HISTORIC AND DESIGN REVIEW COMMISSION

June 16, 2021

HDRC CASE NO: 2021-264
ADDRESS: 922 E CROCKETT ST
LEGAL DESCRIPTION: NCB 583 BLK 8 LOT 3 & E 3.71 FT OF 4
ZONING: RM-4, H
CITY COUNCIL DIST.: 2
DISTRICT: Dignowity Hill Historic District
APPLICANT: Ligaya Thompson
OWNER: THOMPSON LEE CAPITAL LLC
TYPE OF WORK: Window replacement
APPLICATION RECEIVED: May 26, 2021
60-DAY REVIEW: Not applicable due to City Council Emergency Orders
CASE MANAGER: Edward Hall

Window Replacement Schedule

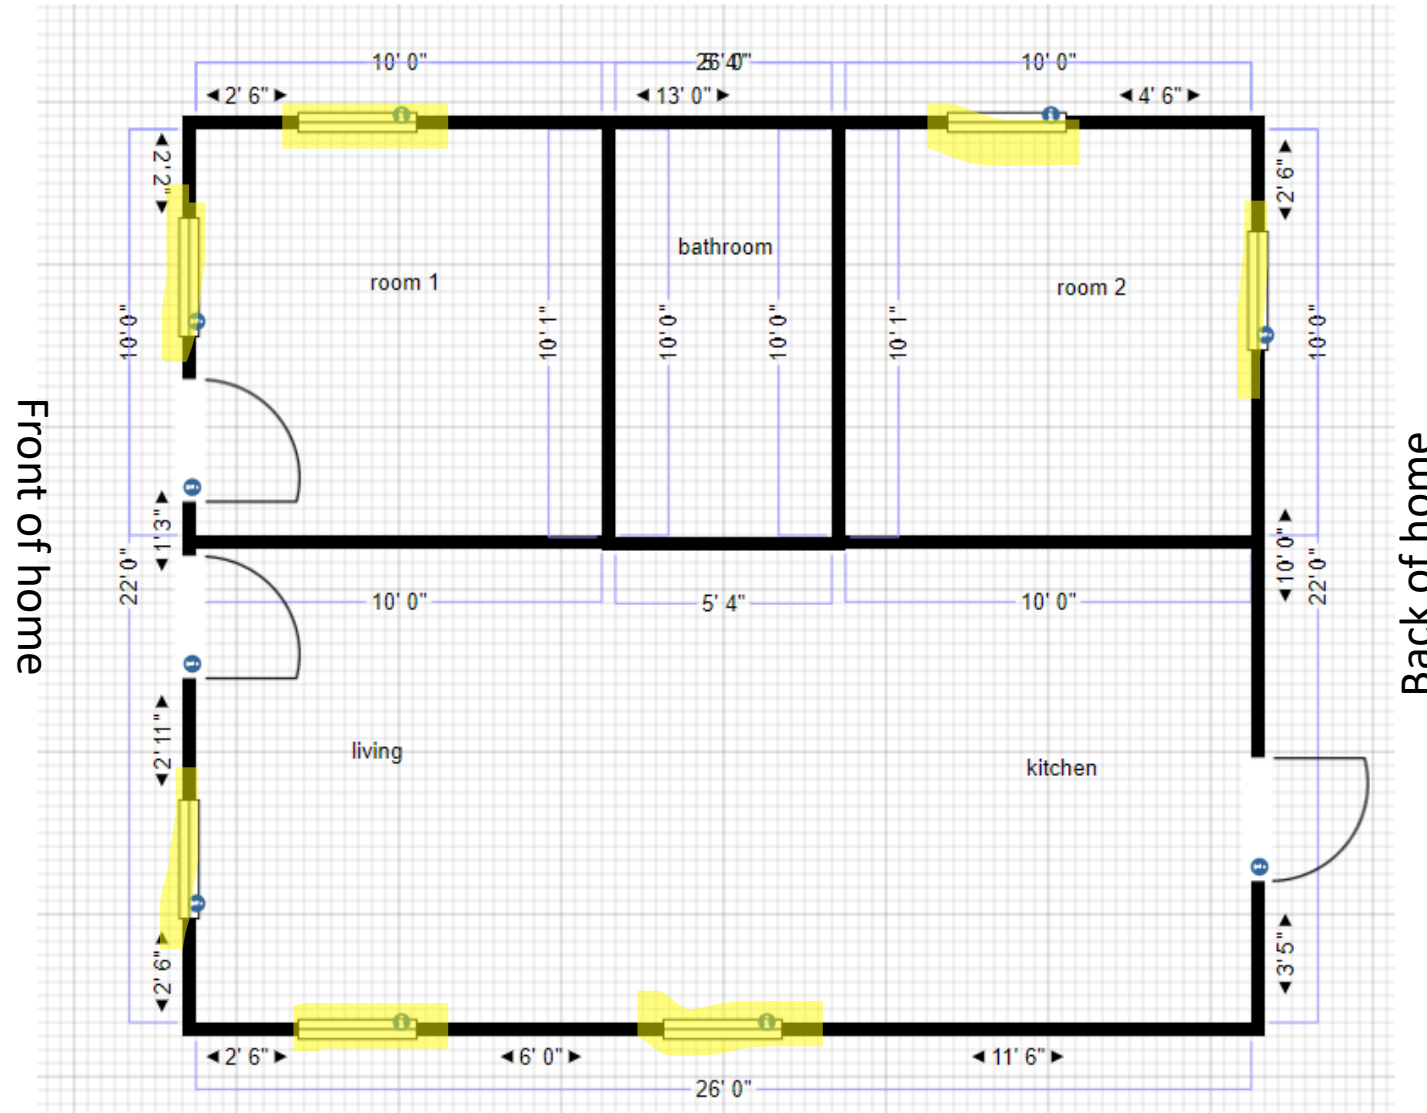
- c. WINDOW REPLACEMENT – The applicant has proposed to replace seven (7) wood windows. OHP staff performed a site visit on June 3, 2021, and found five of the seven wood windows to be in a repairable state. One existing window featured non-original sashes and the other was missing a bottom sash and had significantly deteriorated. Both of these windows are located in room 1 on the plan.

- 1. Staff recommends approval of item #1, the removal of the existing siding to provide structural and framing repairs to the historic structure with the stipulation that all framing be done in-kind, that window openings are fully documented and remain in their exact location, and that existing, original siding be repaired and re-installed.
- 2. Staff does not recommend approval of item #2, window replacement. Staff recommends repair of the existing windows with in-kind replacement of only two windows, both located in room 1, noted on the floor plan.
